**City of Ryde
Local Planning Panel Supplementary Report**

DA Number	LDA2018/0385
Site Address & Ward	8 Grove Lane, Eastwood West Ward
Zoning	R2 Low Density Residential
Proposal	New multi-dwelling housing development comprising three (3) x two (2) storey, three (3) bedroom dwellings, 1.0 metre high front fence, associated car parking and tree removal.
Property Owner	Xiao Chun Yan
Applicant	Steve Wu
Report Author	Hussein Bazzi – Assessment Officer
Lodgement Date	4 October 2018
Recommendation	Approval
Attachments	Attachment 1 – Conditions of Consent Attachment 2 – Amended Plans Attachment 3 – Original DA report Attachment 4 – Submission from Mr Francis Wiffen dated 9 September 2019 Attachment 5 – Submission from My James Ryan dated 12 September 2019

Figure 1: Shadow diagrams provided by Francis Wiffen. Note: Green shading indicates shadow cast and purple/pink is the usable area contained within the private open space of 5 Lilac Place.

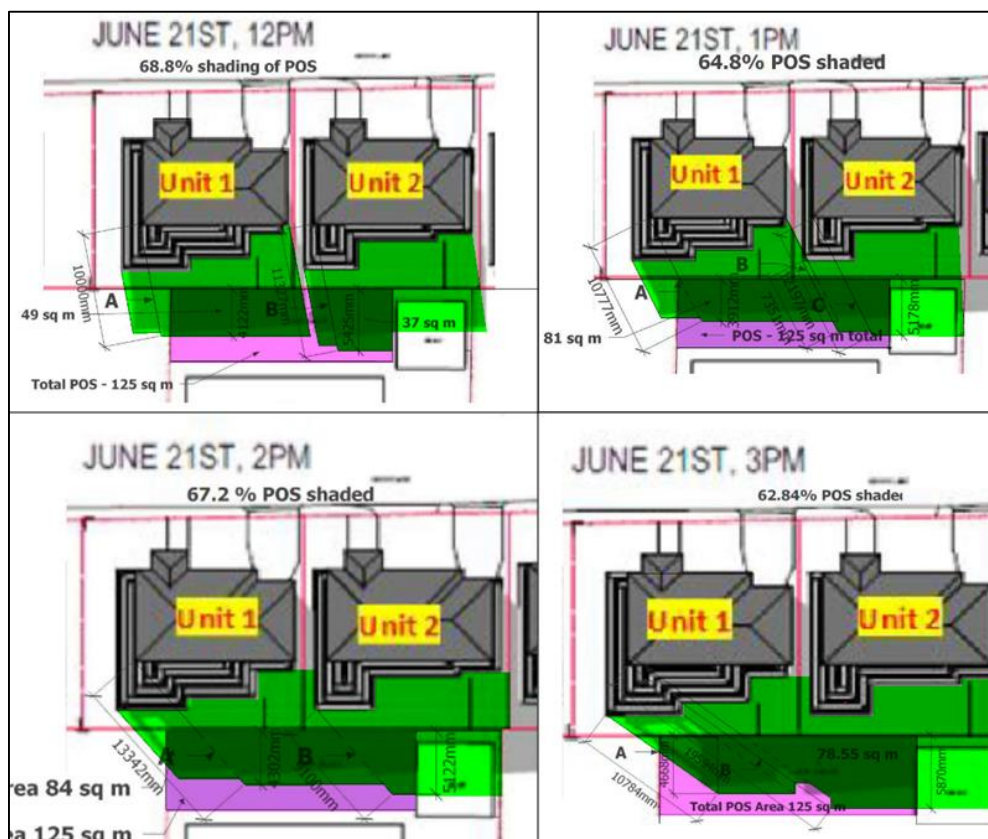
The submission received from Francis Wiffen dated 9 September 2019 raised concerns with the assessment of the shadow impact between the times of 12pm to 3pm on 21 June. Concern was raised that the shadow diagrams did not correctly consider the existing private open space level of RL89.90 of the adjoining property at

5 Lilac Place and the proposal was non-compliant with Section 3.9 (b) Overshadowing and Access to Sunlight. This section of the DCP states:

The submission included shadow diagrams as shown in **Figure 1**.

The shadow diagrams submitted by the applicant are consistent with those prepared by Mr Wiffen.

The total area of usable POS located at the rear of 5 Lilac Place is 125m², this area was determined in the submission by Francis Wiffen and confirmed with Council's measurements on the amended shadow diagrams. An analysis of the diagrams provided by the applicant and Mr Wiffen's submission indicates that the rear private open space of 5 Lilac Place (**Figure 3**) will not receive two (2) hours solar access between 9am and 3pm. The following table below is a comparative analysis between the existing shadow cast of the boundary fence, the proposed development and the change in solar access received.

As demonstrated above, the existing POS of 5 Lilac Place is already over shadowed by the existing boundary fence and the impact of overshadowing as a result of the proposed development will not be reduced greater than 20%. The proposed development therefore complies with the DCP requirements. Notwithstanding this, the additional shadow cast by the development can be considered acceptable for the following reasons:

Figure 5: Total Areas of POS.

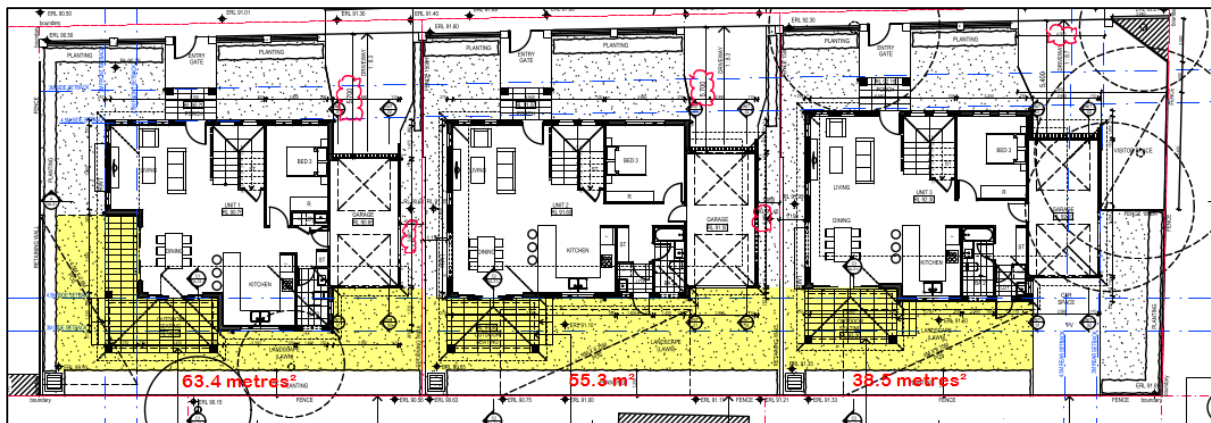
The submission further stated that the private open spaces were not sufficient and did not meet the minimum areas as required under Section 3.6(a). The areas for private open spaces are illustrated in the table and **Figure 5** below. The areas comply with Council’s requirements.

Unit No.	No. of bedrooms	DCP Requirement	Proposed POS
1	3	35m ²	63.4m ²
2	3	35m ²	55.3m ²
3	3	35m ²	38.5m ²

Figure 3: Southern elevation

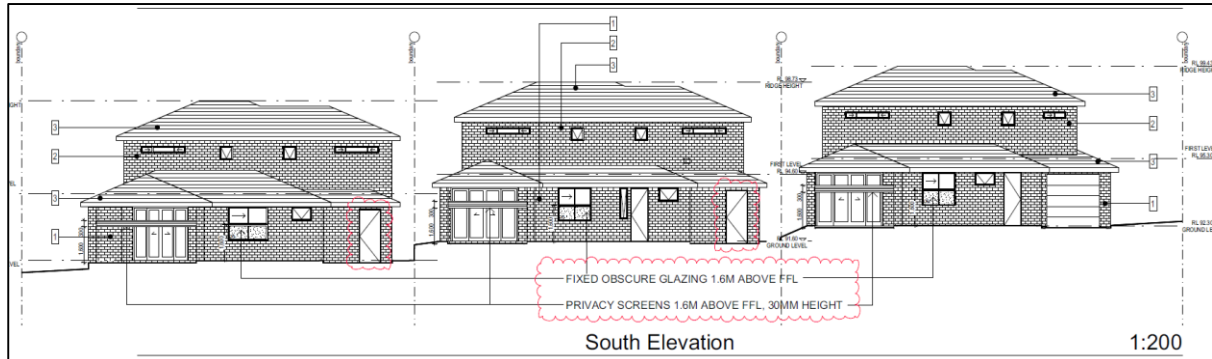
4.2.6 The submission raised additional concerns that the development results in privacy and overlooking impacts to 5 Lilac Place from all openings along the southern elevation of the development.

- **Condition 32 - Obscure Glazing.** *The kitchen windows of all dwellings are to engage the use of fixed obscure glazing from a minimum height of 1.6m above FFL. Details demonstrating compliance with this condition are to be provided in the plans for the **Construction Certificate**.*

The amended plans provide for the kitchen windows to be fixed obscure glazing to a minimum height of 1.6m above the finished floor level (FFL) of all dwellings (**Figure 6**). This design change addresses the recommendation of Condition 32 and this condition is no longer required.

Figure 4: Sections (Note: Privacy screens are subject to a minimum width of 500mm as per amended **Condition 33**).

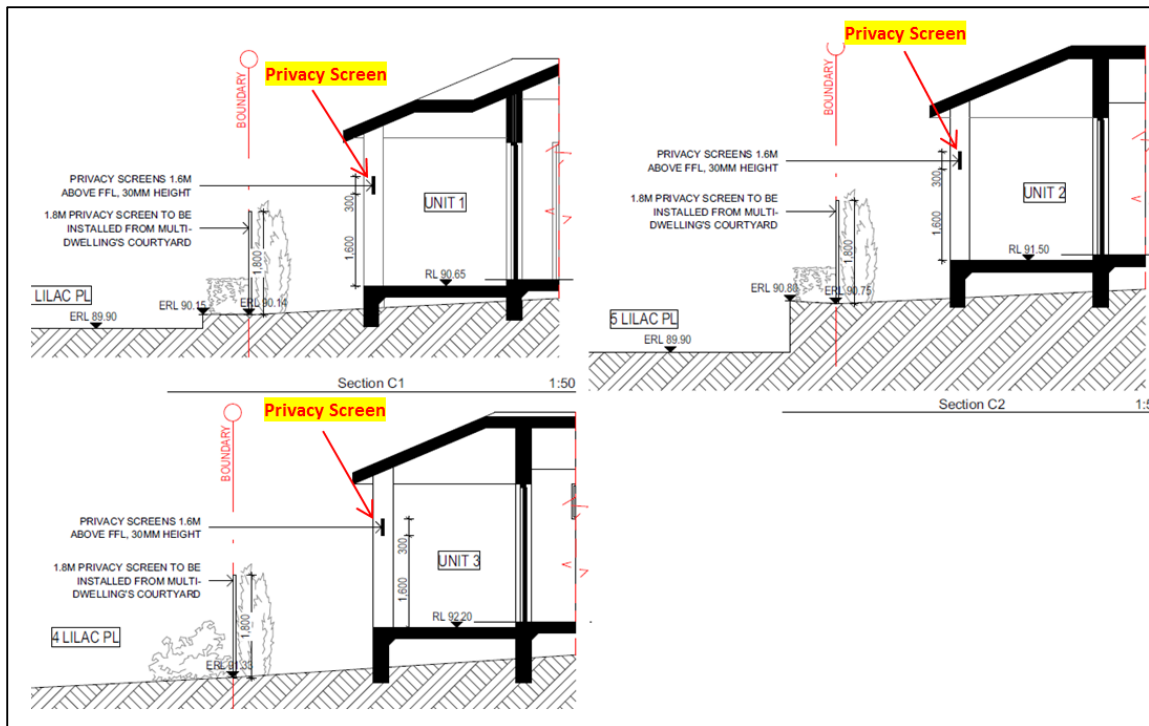
- **Condition 33 - Privacy Screens.** *The provision of privacy screens are to be erected to the southern elevation of the alfresco's of each unit. The bottom of the privacy screens are to be erected in accordance with the following heights:*
 - Unit 1: RL92.25 (1.6m above FFL);
 - Unit 2: RL93.10 (1.6m above FFL); and,
 - Unit 3: RL93.80 (1.6m above FFL).

The purpose of this condition was to ensure that there was no overlooking when an adult is standing in the alfresco areas. Further sections (**Figure 7**) of the proposed alfresco areas for all Units have been provided which incorporates a 300mm privacy screens to a height of 1.6 metres above the finished floor level. This is consistent with the recommendation of Condition 33. It is however recommended to amend Condition 33 for the privacy screens to be widened to a width of 500mm and be 1.4 metres above the finished floor level of the alfresco. This will ensure that adequate privacy is maintained between the development and private open space of 5 Lilac Place.

Figure 8: Amended car parking arrangements for each dwelling is shaded in yellow and visitor space is shaded in blue.

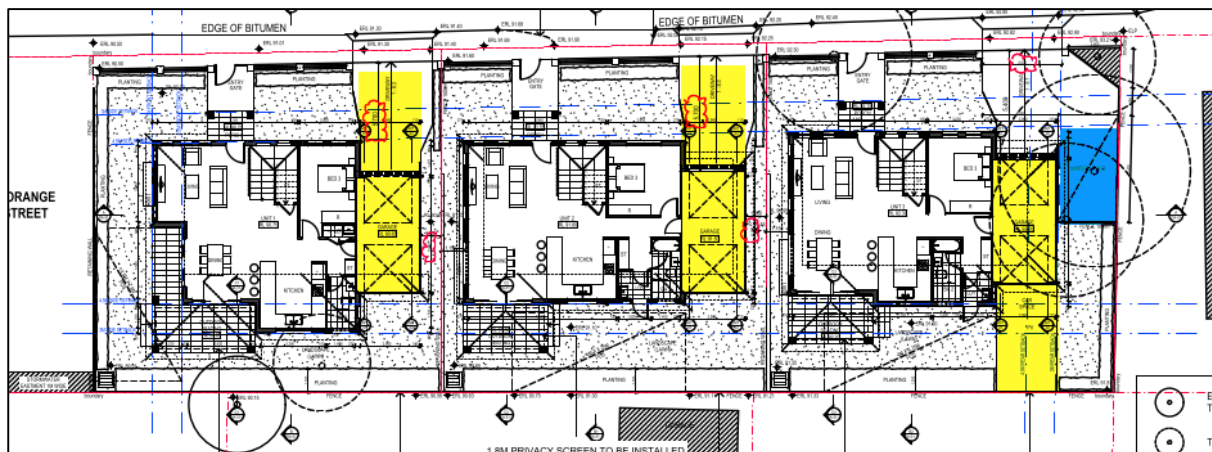
The proposal considered by the Panel provided for a single enclosed garage and a hard stand tandem parking space in the rear to provide for two (2) spaces. The proposal also accommodated a visitor parking space at the eastern end of the sites frontage. Concern was raised by the Panel regarding this arrangement.

The proposal was amended in response to concerns raised by the Panel. The amended plans (**Figure 8**) have deleted the tandem spaces for Units 1 and 2. The tandem space arrangement for Unit 3 is retained in order to provide sightlines to Grove Lane to enable vehicles to safely exit from the visitor parking space in accordance with AS 2890.1 and maintains unobstructed access to the visitor car space.

The amended proposal for Units 1 and 2, rely upon the driveway to accommodate the secondary parking space on site. This arrangement is non-compliant with Section 3.8.1 (e) and (h), which requires tandem arrangements and parking spaces not to be located between garages and the street. The use of the driveway for a secondary parking space does not result in a physical change to the development.

- Unit 1 and 2 garage have now provided a setback of 5.7m from the front fence. For an off-street parking space, the AS2890.1 requires a minimum length of 5.4m, thus this arrangement will permit a secondary space to be parked within the front setback whilst providing sufficient manoeuvring area around the parked vehicle. The internal dimensions of the garages still meet the requirements of AS2890.1 resulting in a fully compliant design.
- As highlighted by the previous assessing development engineer, the access to the visitor space adjacent to Unit 3 has been amended to ensure adequate sight distance is provided for drivers exiting the designated space.
